Notification for KS32C50100 Design Bugs

2 February, 2000
(Ver 4.0)

Samsung Electronics Co., Ltd.

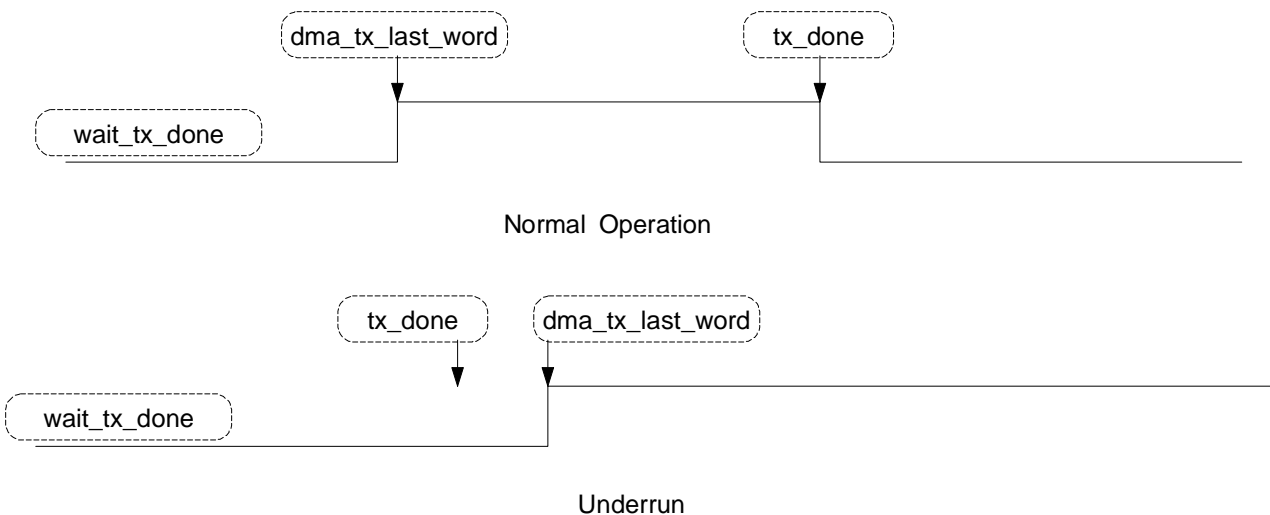
A HDLC frame received after 2 flags (figure) has always CRC error.

In state machine, two flags case was not considered. There is no work-around.
